**Window G**  
**Sector Development Plan**

**CASE NUMBER: SD-95-2, AX-95-10, Z-95-82**

## ADDENDUM TO WINDOW G SECTOR DEVELOPMENT PLAN

JANUARY 20, 1997

EXISTING DRAINAGE CONDITIONS  
WINDOW "G", LA CUEVA SECTOR PLAN

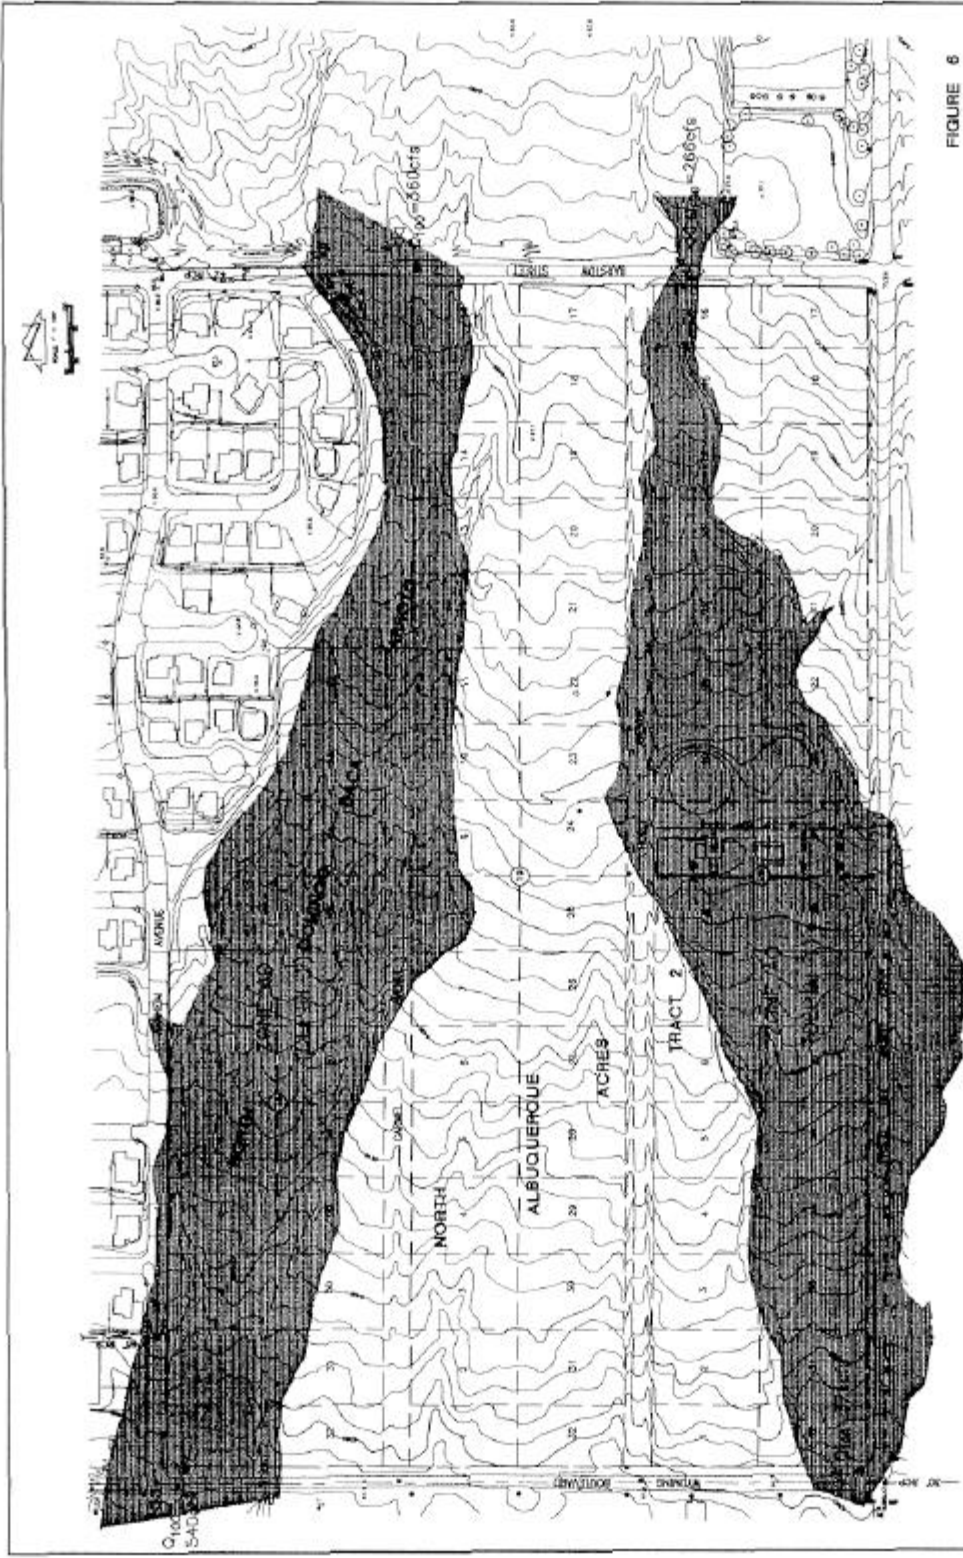
Figure 6 shows the existing drainage conditions for Window G. As shown by this Figure, two (2) 100-year designated flood zones impact the plan area. The North Domingo Baca Arroyo enters at the northeast corner and is characterized by an AO (Depth 1) Zone. The existing offsite flow entering this flood zone from upstream is 360 cfs. The existing flow downstream at the Wyoming Boulevard N.E. crossing is 540 cfs. This hydrology was obtained from the North and South Domingo Baca Arroyos and Paseo del Norte Corridor Drainage Management Plan prepared for AMAFCA by Resource Technology, Inc, December 1991.

<p>MASTER DRAINAGE PLAN</p> <p>WINDOW "G", LA CUEVA SECTOR PLAN</p>	
	<p>NO. 1 3</p>	<p>DATE: 06-1975</p> <p>BY: [Signature]</p>

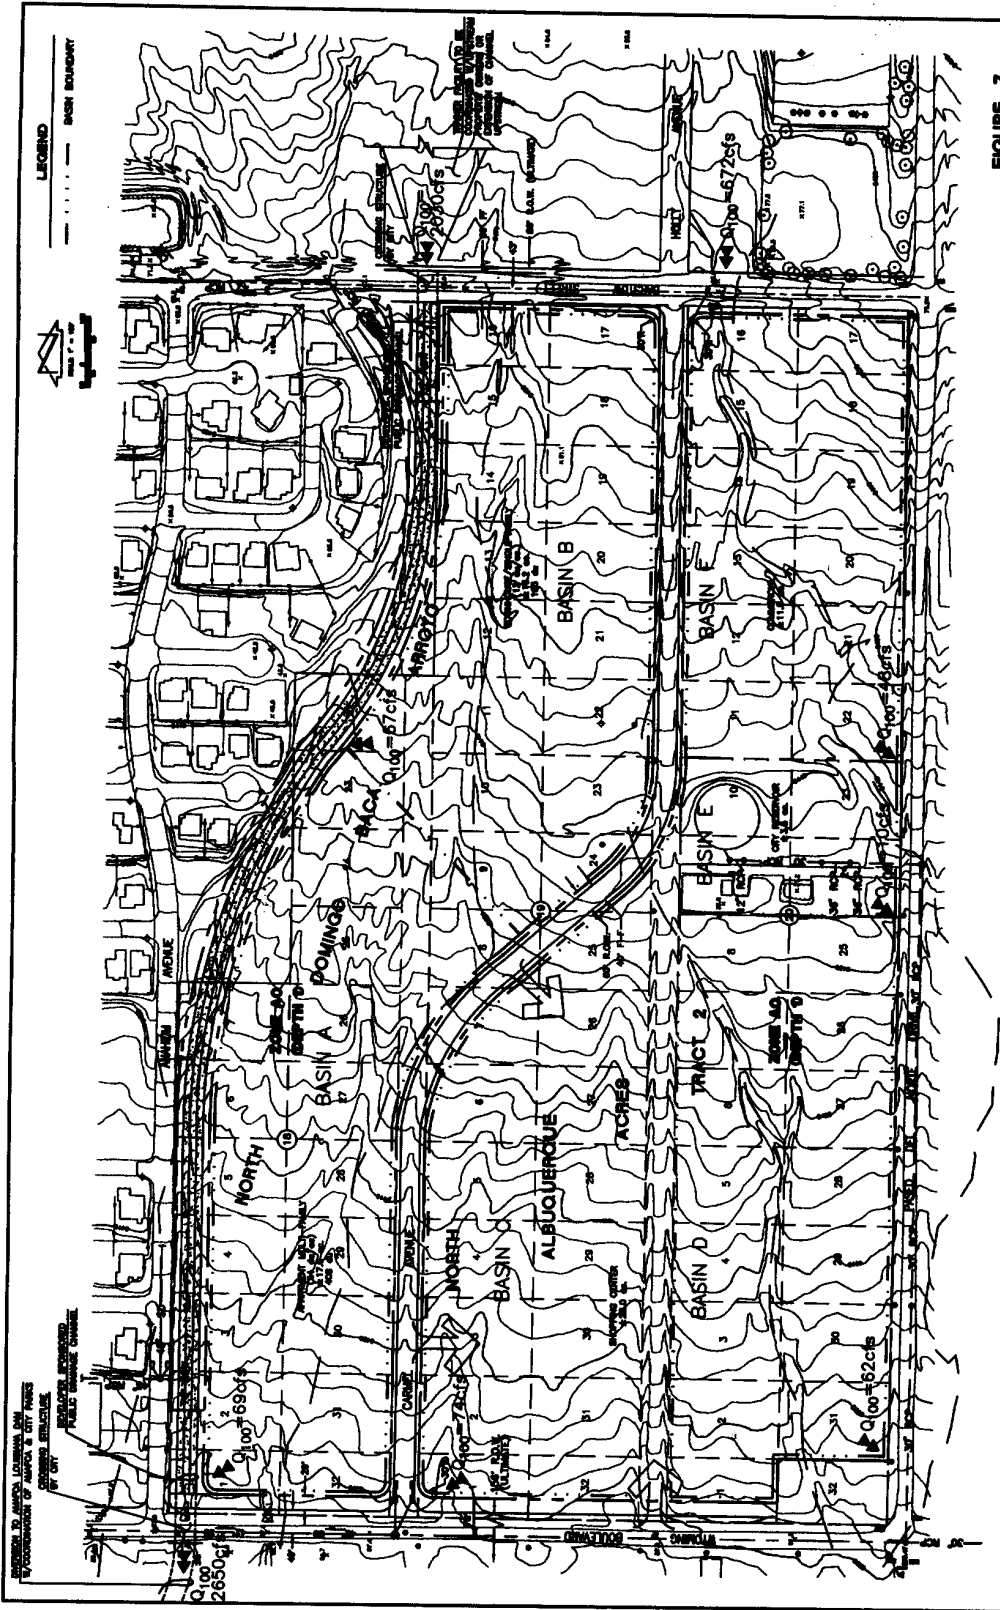
Figure 7 shows the Proposed Drainage Improvements, in conceptual form, within Window G. Runoff associated with the North Domingo Baca Arroyo will be carried through the north portion of the planned area within a public drainage channel. A preliminary profile of this channel is shown on Figure 8. A typical channel section is shown on Figure 9. It is proposed that this channel will meet current City **and/or** AMAFCA Standards. Runoff contained within the existing 48" storm drain within Anaheim Avenue N.E. will be discharged directly into this channel. This will eliminate a portion of the runoff which currently enters an existing pond which lies outside of the window and north of the planned area. This small diversion will eliminate the presence of a public storm drain on private property. This will make the system more accessible to the City and/or AMAFCA.

As referenced above, crossing structures will be constructed **in conjunction with development as required at the Development Review Board (DRB).** Diverting the runoff carried by the arroyo to the AMAFCA/Louisiana Dam will require coordination with both AMAFCA and City parks. A City park site will lie immediately west of the site on the west side of Wyoming Boulevard N.E. Final plans for the development of the park site are not available, however, it is anticipated a park will be developed on that site at a later date. Because of this, the diversion should be temporary in nature so as to allow maximum flexibility in the design and construction of the City Park Improvements. Pre-application meetings indicate that this is an acceptable concept to follow. It should be stressed that this diversion will require close coordination with both AMAFCA and City parks.

FIGURE 8

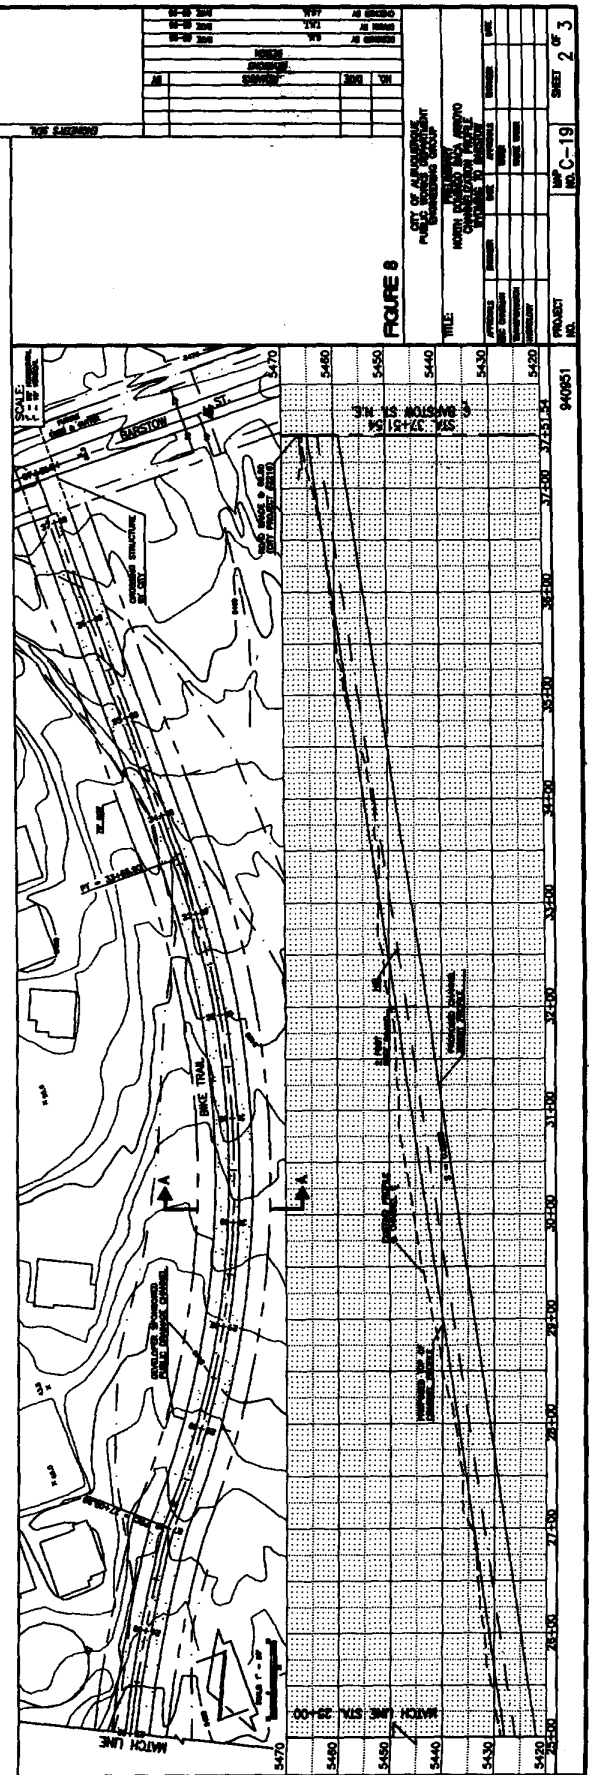
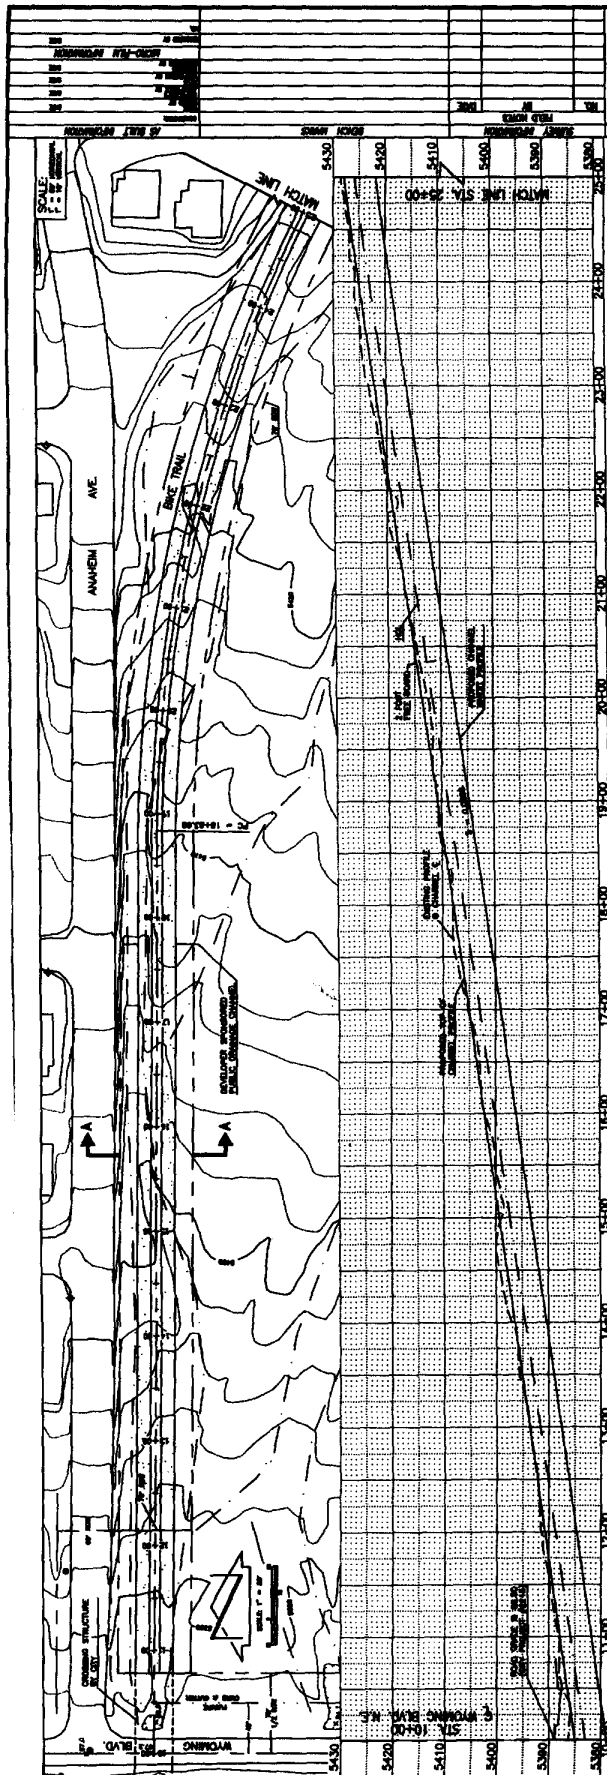
FIGURES 8 and 9, which appear at the back of the Sector Plan, illustrates concepts for the design of a public drainage channel between Wyoming Boulevard N.E. and Barstow Street N.E. Final alignment, grade, cross-section and material are subject to adjustment and/or modification with concurrence/approval of the governmental agencies having jurisdiction.

FIGURE 9

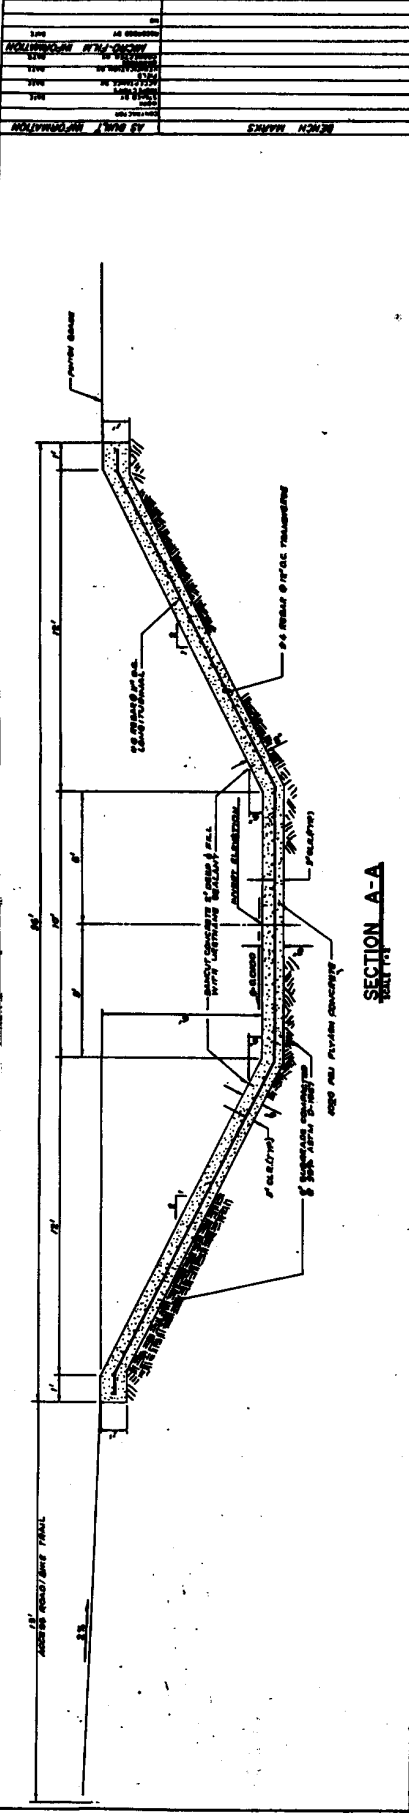
The design flow for the channel has been selected as 2,650 cfs as taken from the RTI Report. The Table from which Peak Discharges in the developed (future) conditions at critical locations has been reprinted as part of Figure 9. Figure 9 also includes Channel Hydraulics Calculations and an Analysis of Channel Freeboard. These calculations are presented in support of the typical channel section illustrated as part of Figure 9.
